## **TEES CCGP PROJECT – RESPONSE TO ENVIRONMENT AGENCY LETTER DATED 13 SEPTEMBER 2018 (REF. NA/2018/114039/08-L01) REGARDING CARBON CAPTURE READINESS**

This memo has been prepared by AECOM on behalf of Sembcorp Utilities (UK) Limited (the 'Applicant') and provides a response to the Environment Agency's letter (reference NA/2018/114039/08-L01) dated 13 September 2018, which raises a number of matters in respect of the Carbon Capture Readiness ('CCR') of the Tees CCGP Project.

## **APPENDIX 1 – EXIT POINT PLAN**

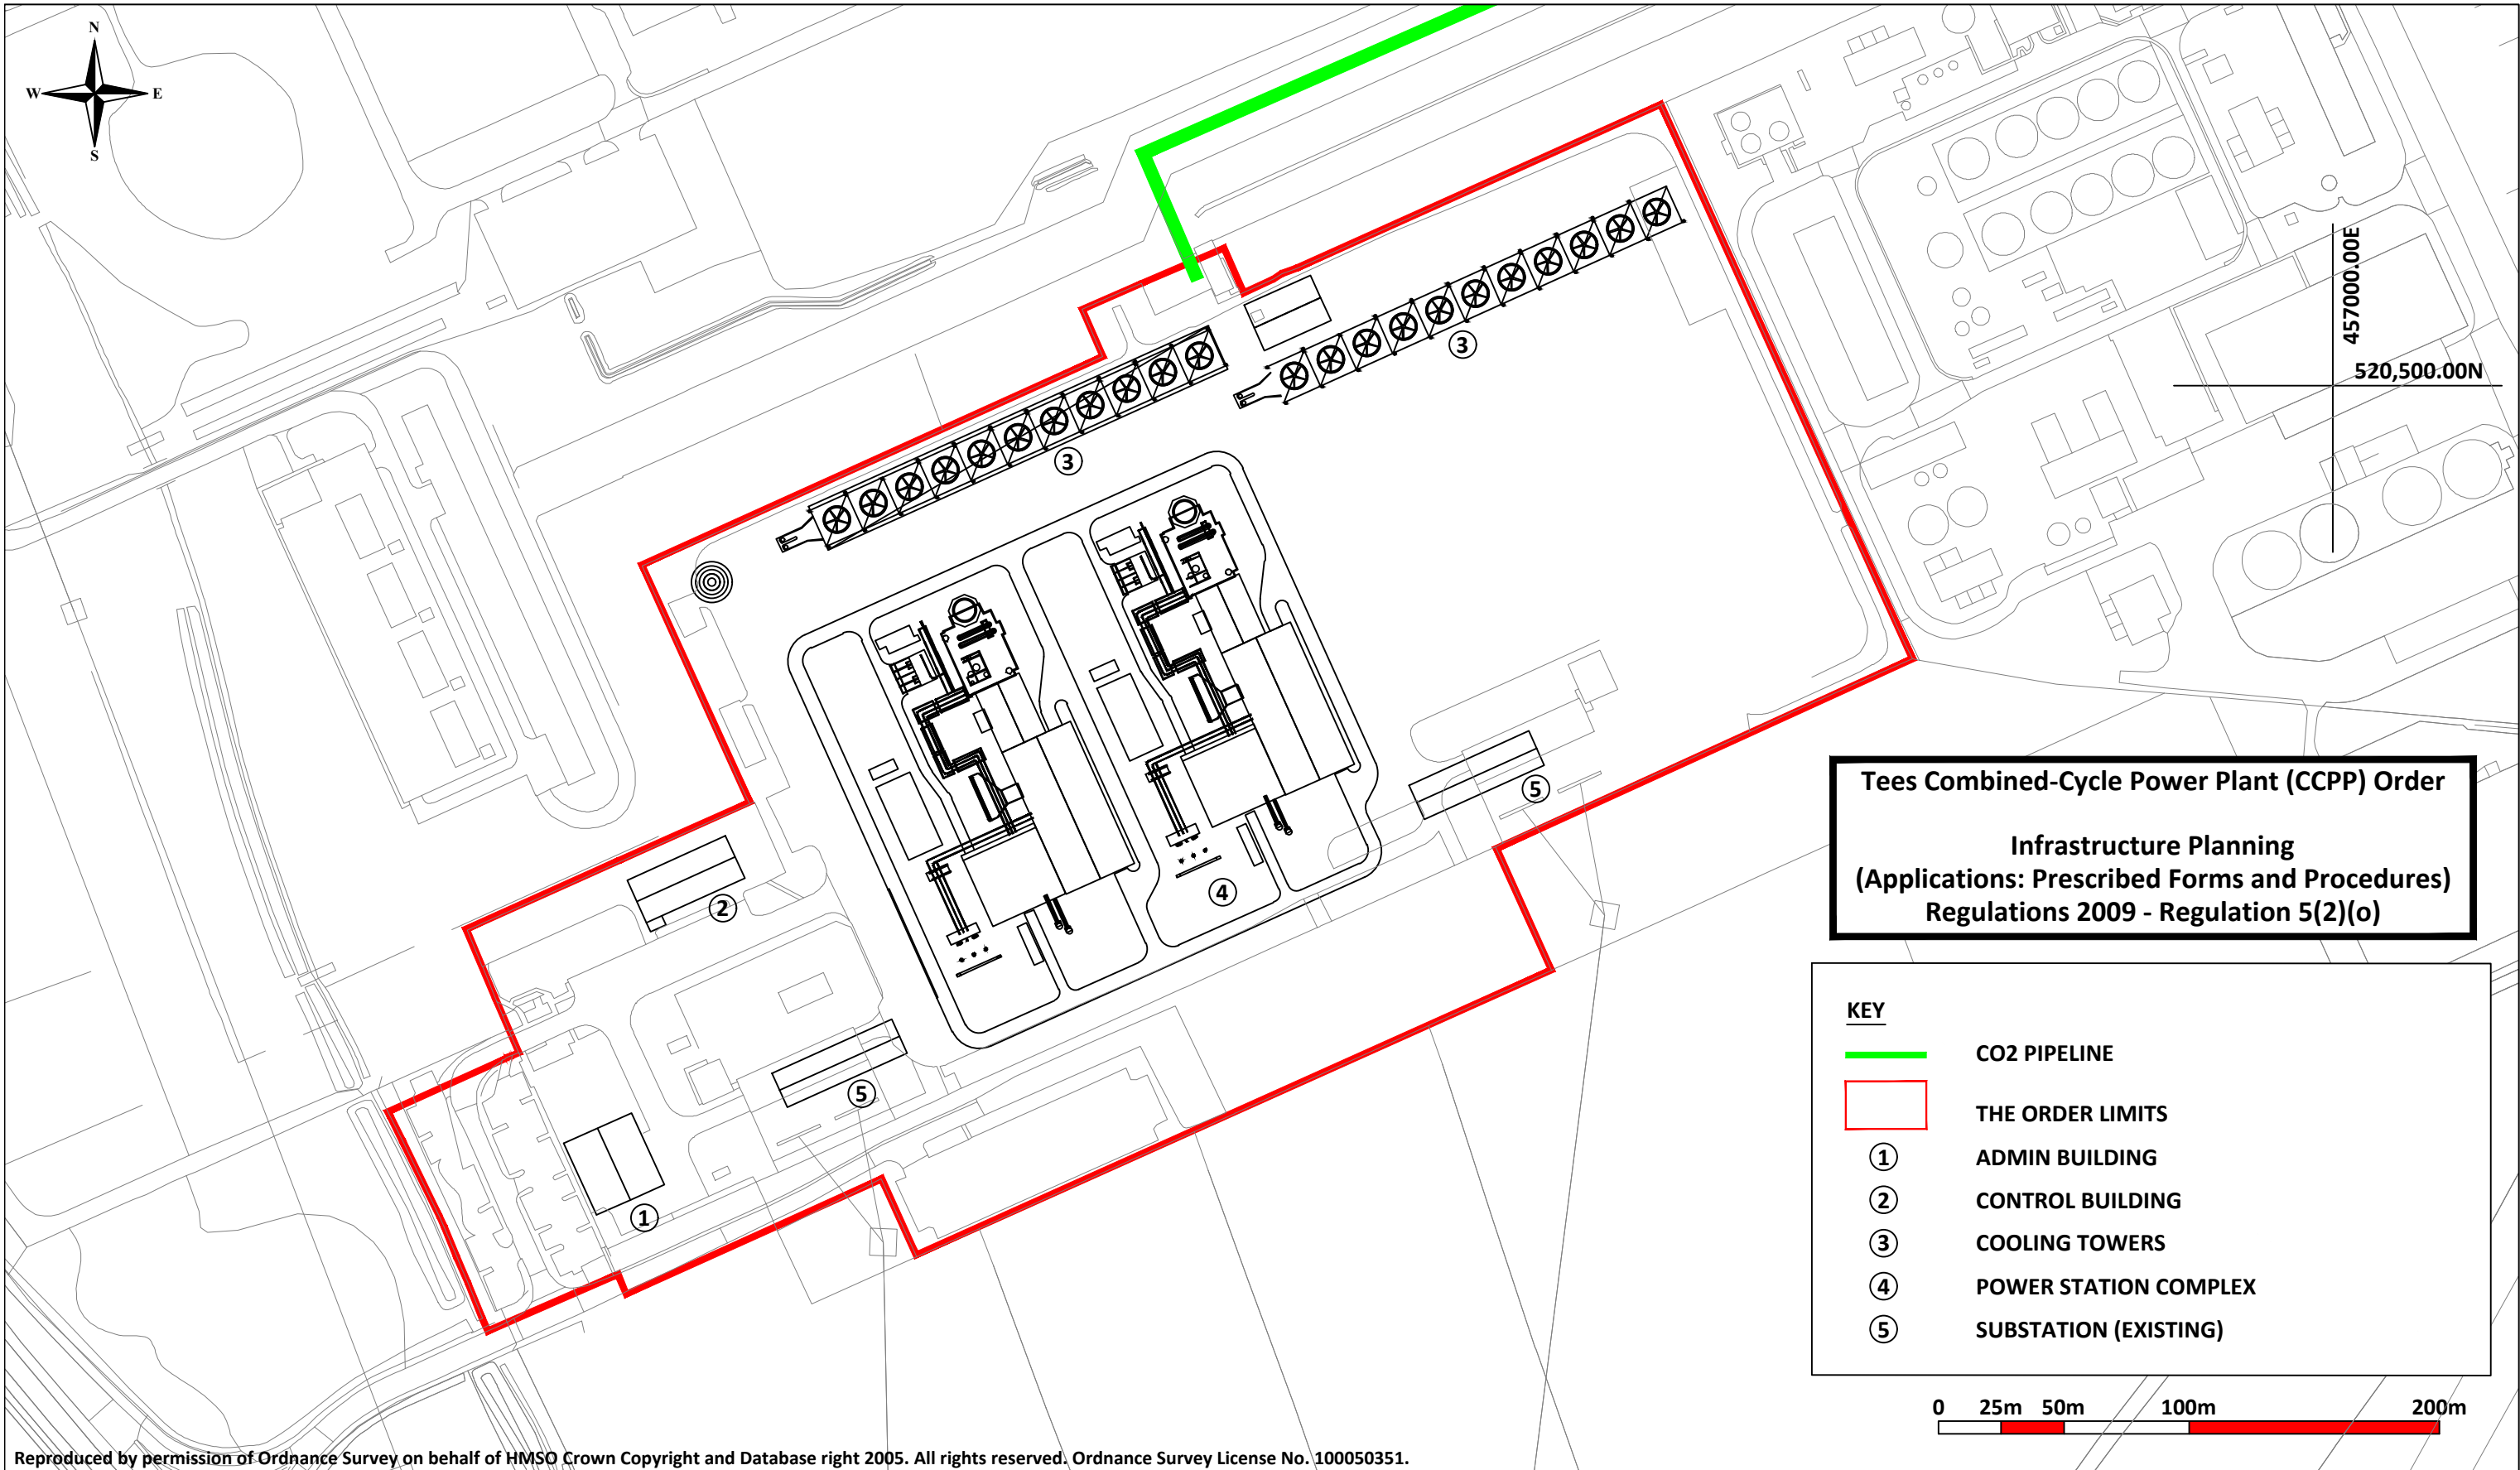
### **C2 - Power Plant Location**

The Applicant has produced a plan that shows the exit point of the CO<sub>2</sub> pipeline from the curtilage of the plant – see **Appendix 1** to this note.
